IEEE P802.15 Wireless Personal Area Networks

Project	IEEE P802.15 Working Group for Wireless Personal Area Networks (WPANs)	
Title	Changes for the removal of using Imm-ACK frames as confirmation of Request commands	
Date Submitted	[22 April, 2004]	
Source	[John Sarallo] [Appairent Technologies] [150 Lucius Gordon Drive, West Henrietta, NY 14586]	Voice: [585-727-2014] Fax: [585-214-2461] E-mail: [sarallo@appairent.com]
Re:	[]	
Abstract	[This document contains a list or proposed changes to IEEE Std 802.15.3.]	
Purpose	[The purpose of this document is to propose changes to IEEE Std 802.15.3 to improve compatibility, performance and clarity in the standard.]	
Notice	This document has been prepared to assist the IEEE P802.15. It is offered as a basis for discussion and is not binding on the contributing individual(s) or organization(s). The material in this document is subject to change in form and content after further study. The contributor(s) reserve(s) the right to add, amend or withdraw material contained herein.

Figure 94 - New

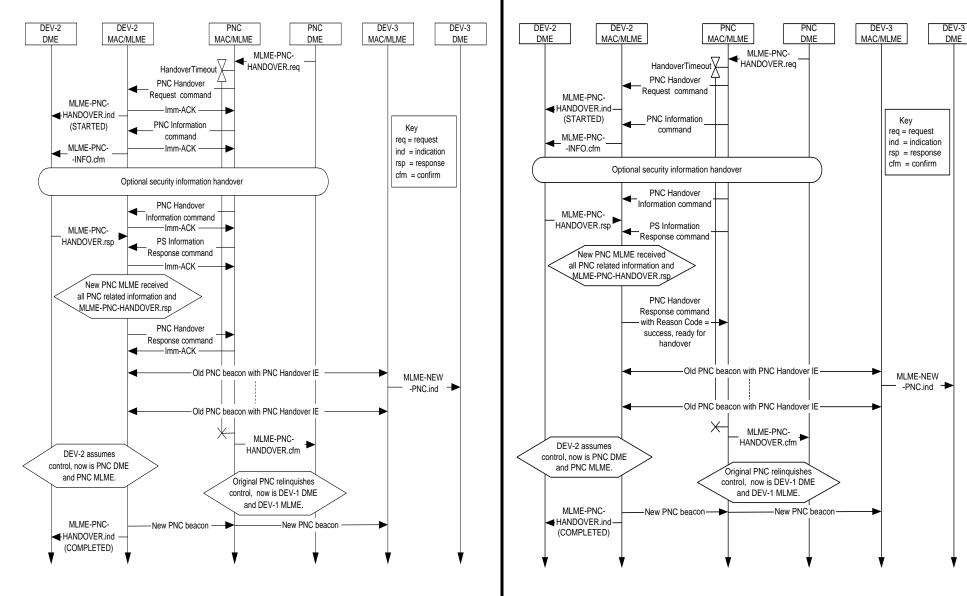
- Imm-ACKs removed.
- Reascon Code of "success, ready for handover" added to the PNC Handover Response command.

Figure 97 - New

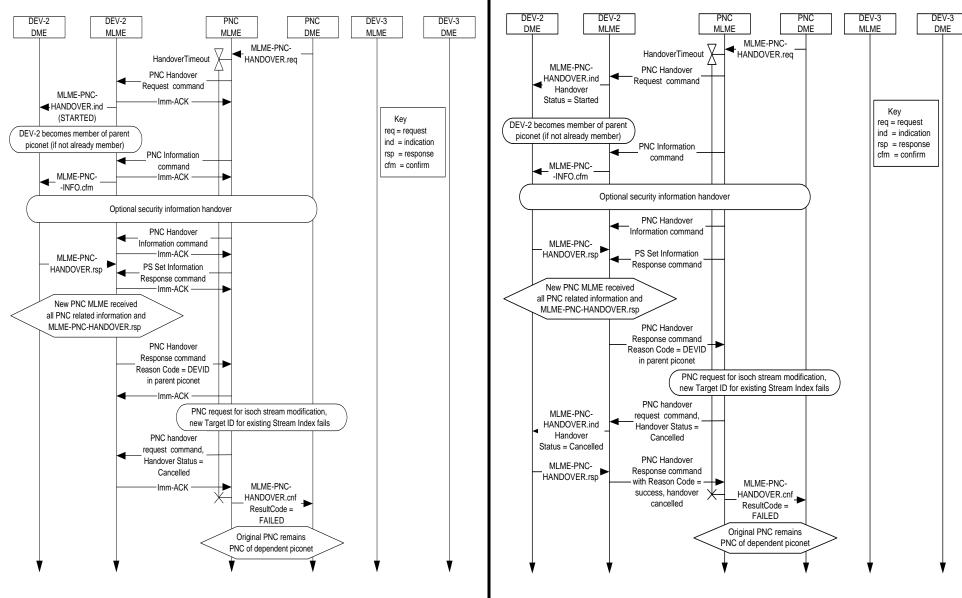
- Imm-ACKs removed.
- Cancellation of handover acknowledged with a PNC Handover Response command with a Reason Code of "success, handover cancelled"

Figure 102 - New

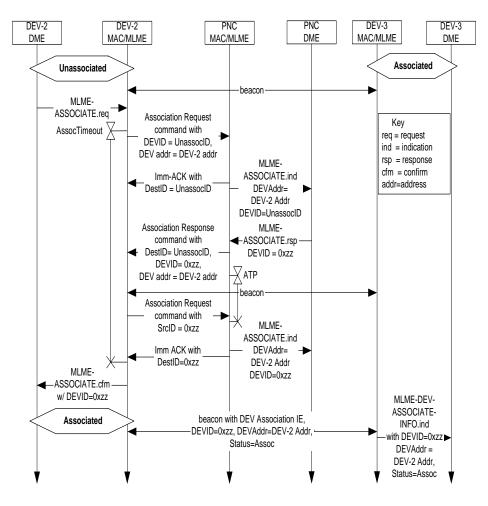
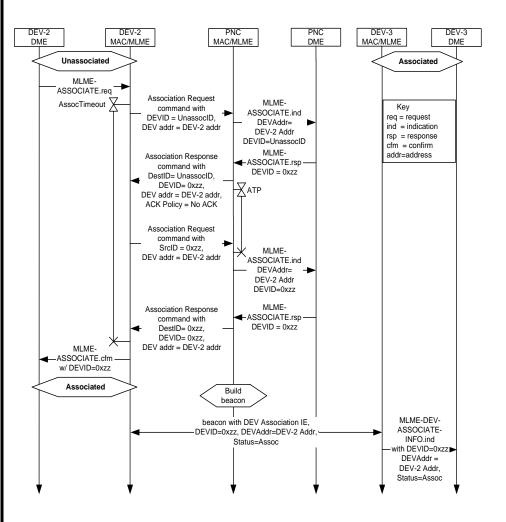
- Imm-ACKs removed.
- ACK Policy for first Association Response command identified as "No ACK"
- Note: As long as standard states that the DestID of the Imm-ACK should equal the SrcID of the previously received frame, then Imm-ACKs do not need to be shown with the varying DestIDs on this MSC.

Figure 103 - New

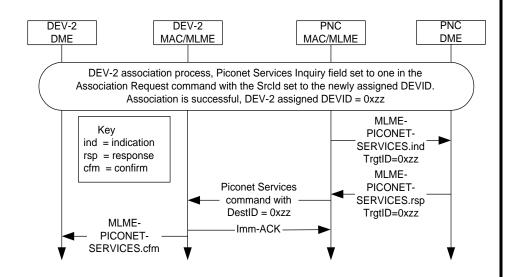
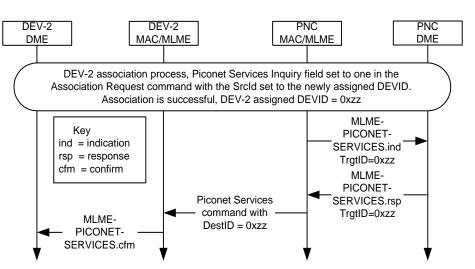
- Imm-ACK removed.
- No timer was started on original, so assumed this should be a "fire and forget" scenario.

Figure 104 - New (Recommended)

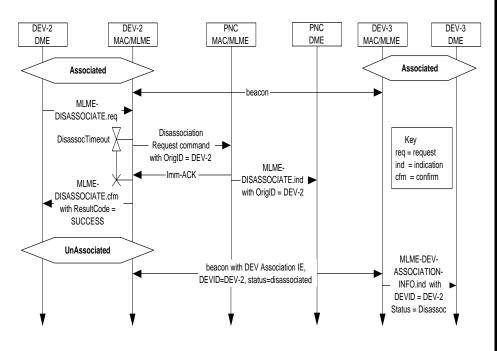
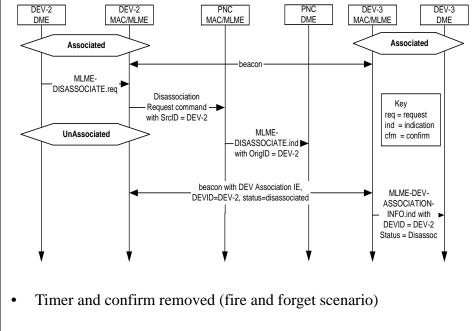
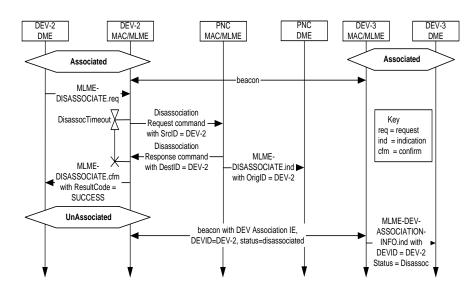
• Imm-ACK replaced with new Disassociation Response command.

Figure 105 - New

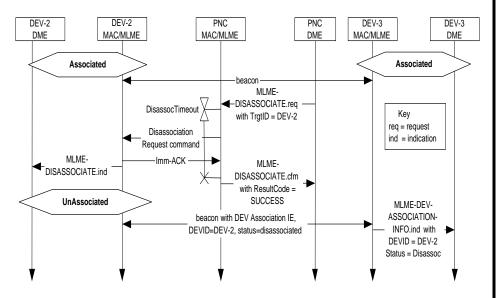
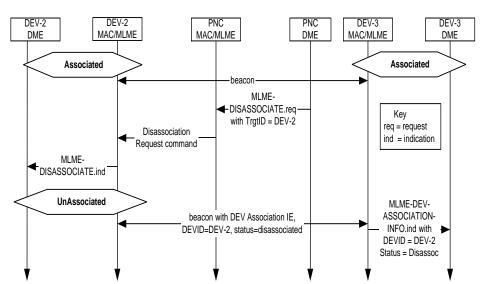
- Imm-ACK removed.
- DisassocTimeout timer removed.
- Note: If the PNC disassociates a DEV, the DEV is disassociated if the DEV responds to the Disassociation Request command or not. Therefore, this scenario is assumed to be a "fire and forget" scenario.

Figure 114 - New

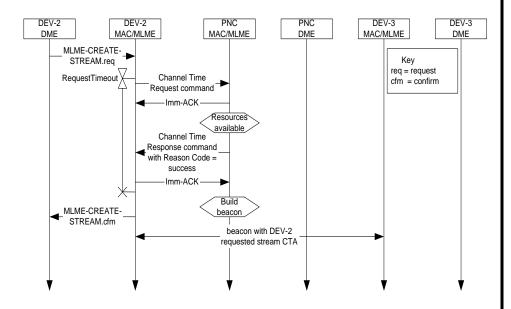
- Imm-ACKs removed.
- New MLME-CREATE-STREAM.indication added (Missing on original MSC)

Figure 116 - New

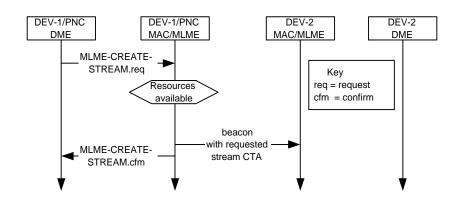
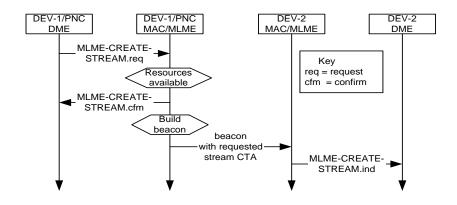
- MLME-CREATE-STREAM.cfm generated after PNC determines that it has resources available (Beacon generation occurs "sometime in the future").
- "Build beacon" task added to be consistent with other MSCs that generate beacons.
- New MLME-CREATE-STREAM.indication added.

Figure 117 - New

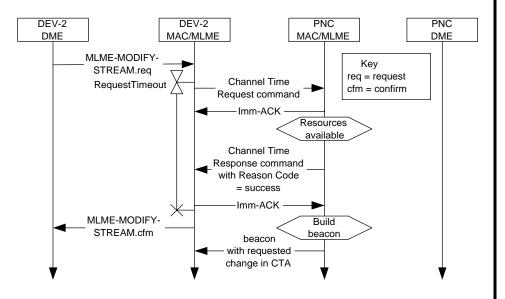
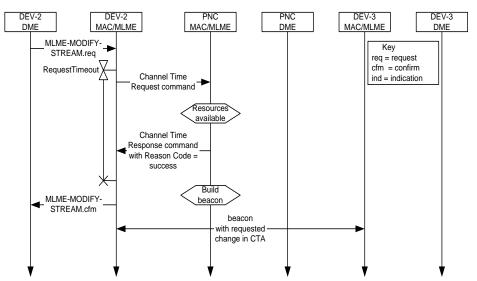
- Imm-ACKs removed.
- DEV-3 added to show it receiving the modified stream information in the beacon.

Figure 118 - New

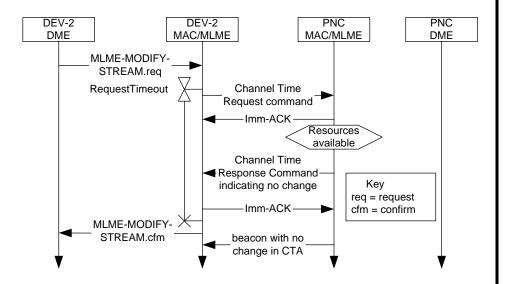
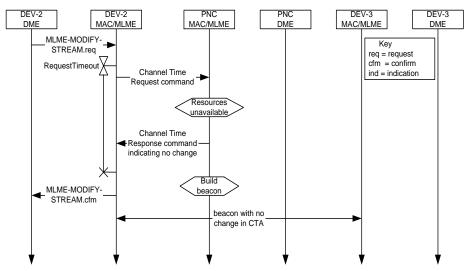
- Imm-ACKs removed.
- DEV-3 added to show it receiving a beacon with no CTA change.
- "Build beacon" added to be consistent with other MSCs that generate beacons.

Figure 119 - New

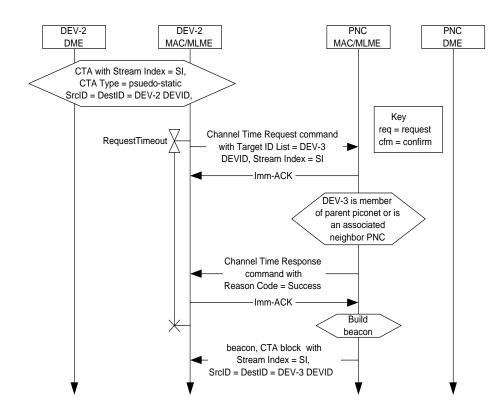
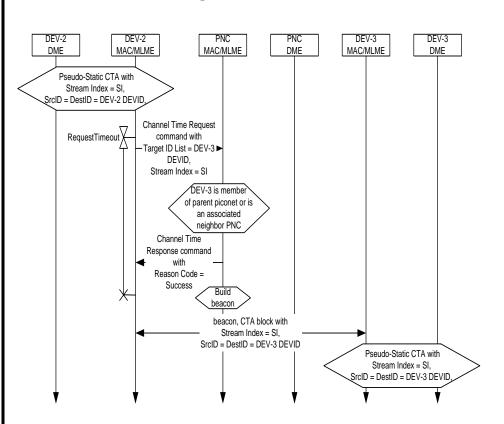
- Imm-ACKs removed.
- DEV-3 added to show it receiving the modified stream information in the beacon.
- State information added to DEV-3 to show it now has the private CTA that DEV-2 originally had.

Figure 120 - New

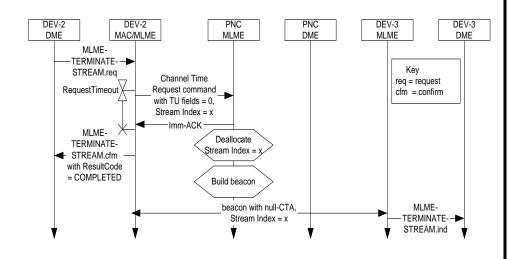
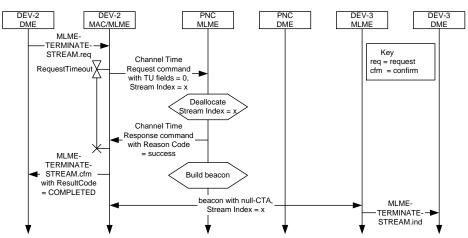
- Imm-ACK removed.
- Channel Time Response command added and generated after the resources are deallocated.

Figure 121 - New

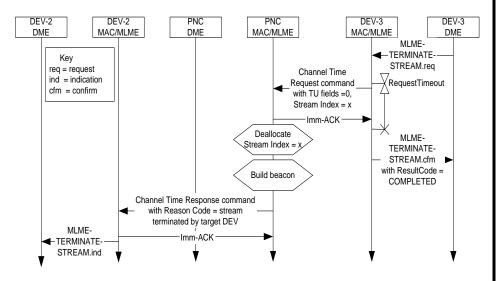
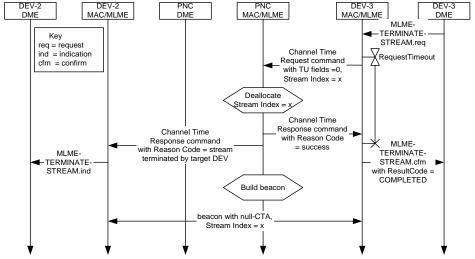
- Imm-ACKs removed.
- Channel Time Response command added from PNC to DEV-3 and generated after the resources are deallocated.

Figure 122 - New

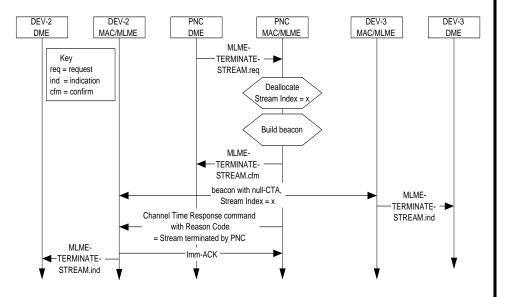
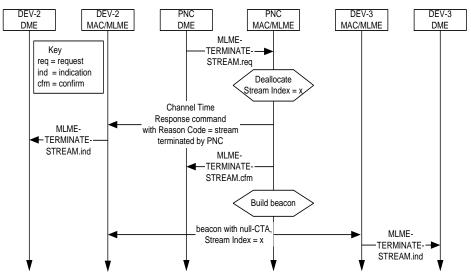
- Imm-ACK removed.
- Channel Time Response command from PNC to DEV-2 moved to occur after the resources are deallocated (Beacon generation occurs "sometime in the future".)

Figure 123 - New

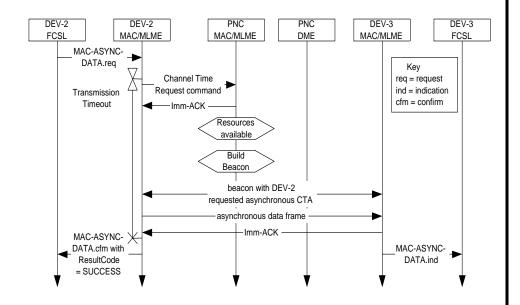
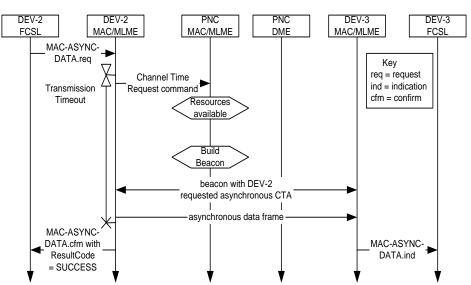
- Imm-ACKs removed.
- MAC-ASYNC-DATA.confirm generated after data is transmitted.

Figure 129 - New (Recommended)

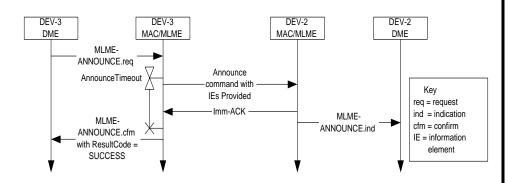
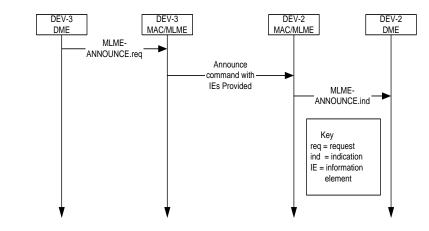
- Imm-ACK removed.
- Announce command renamed Announce Request command.
- New MLME-ANNOUNCE.response primitive added.
- New Announce Response command added.

- Announce commands considered "fire and forget".
- Note: One important piece of information passed via the Announce command is Overlapping PNID information.
- No timeout timer.
- No confirmation.

Figure 131 - New

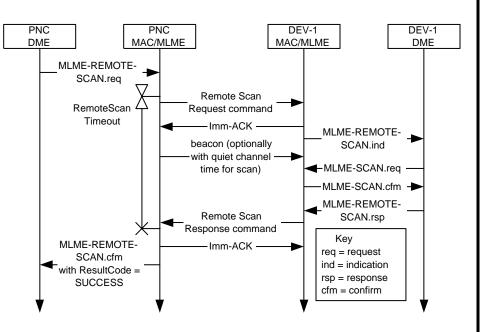
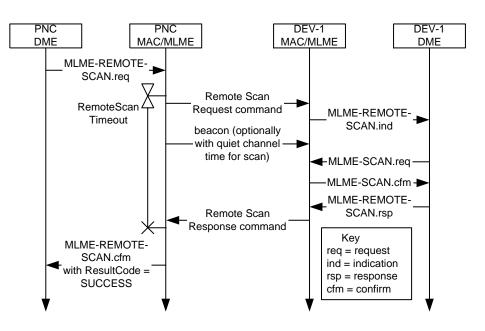
• Imm-ACKs removed.

Figure 136 - New

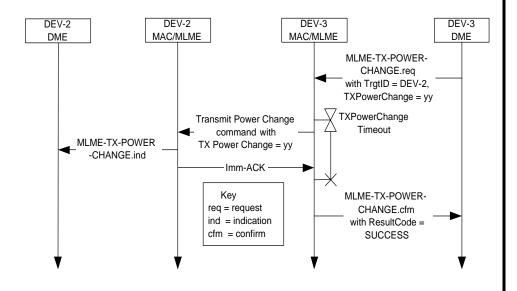
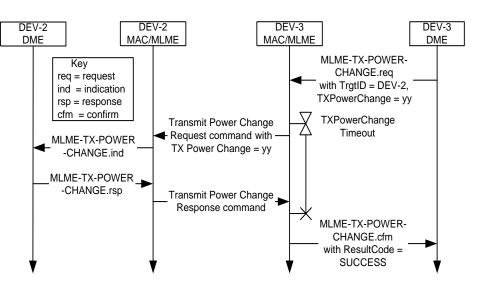
- Imm-ACK removed.
- Transmit Power Change command renamed Transmit Power Change Request command.
- New MLME-TX-POWER-CHANGE.response primitive added.
- New Transmit Power Change Response command added which includes the current power level to aid the requester to know which Transmit Power Change Request commands were received by the target.

Figure 143 - New

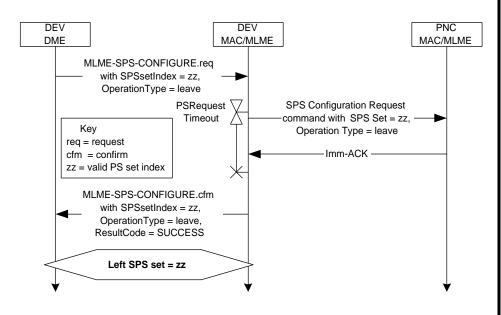
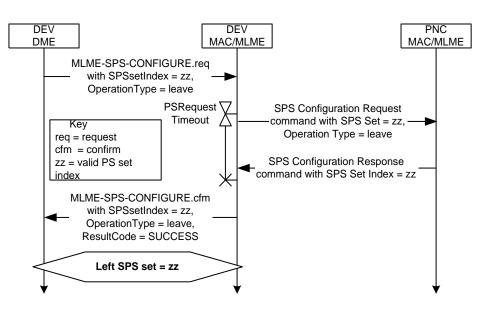
• Imm-ACK replaced with SPS Configuration Response command.

Figure 144 - New

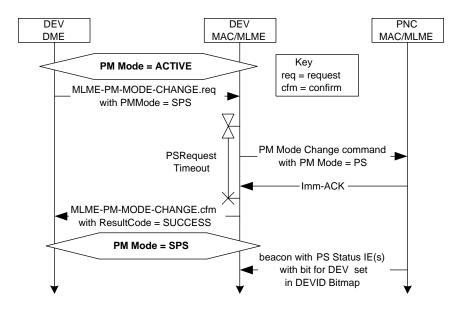
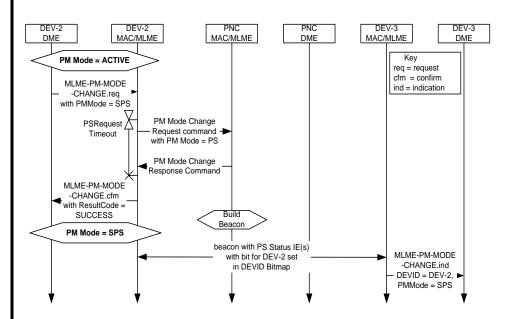
- PM Mode Change command renamed PM Mode Change Request command.
- Imm-ACK replaced with new PM Mode Change Response command.
- DEV-3 added to show a DEV receiving PS Status information in the Beacon.
- New MLME-PM-MODE-CHANGE.indication primitive added.

Figure 145 - New

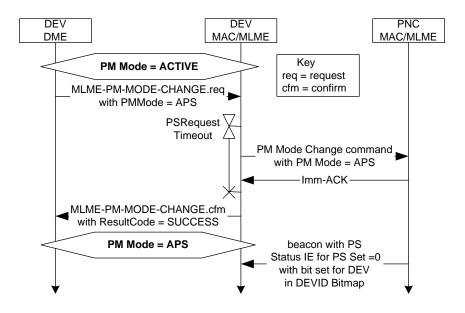
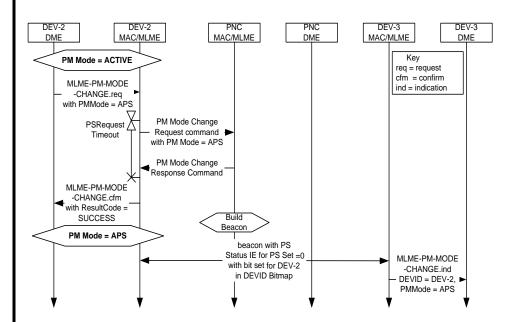
- PM Mode Change command renamed PM Mode Change Request command.
- Imm-ACK replaced with new PM Mode Change Response command.
- DEV-3 added to show a DEV receiving PS Status information in the Beacon.
- New MLME-PM-MODE-CHANGE.indication primitive added.

Figure 146 - New

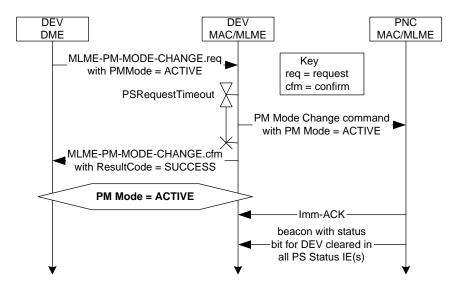
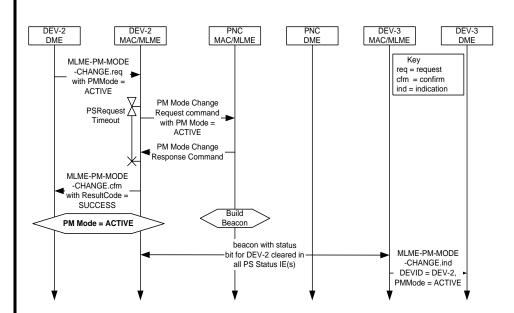
- PM Mode Change command renamed PM Mode Change Request command.
- Imm-ACK replaced with new PM Mode Change Response command.
- DEV-3 added to show a DEV receiving PS Status information in the Beacon.
- New MLME-PM-MODE-CHANGE.indication primitive added.

Figure 147 - Current

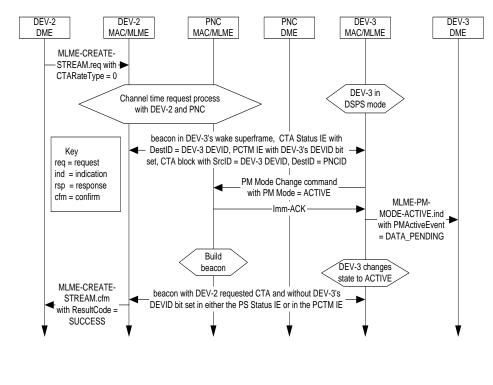
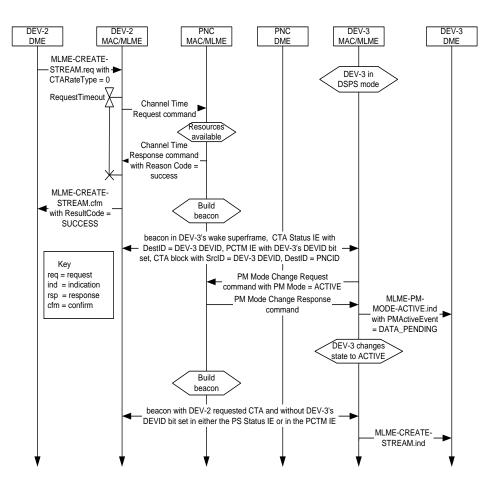
- MLME-CREATE-STREAM.cfm primitive generated after Channel Time Response command is received. The DEV then waits for a beacon with allocated channel time as normal.
- PM Mode Change command renamed PM Mode Change Request command.
- Imm-ACK replaced with new PM Mode Change Response command.
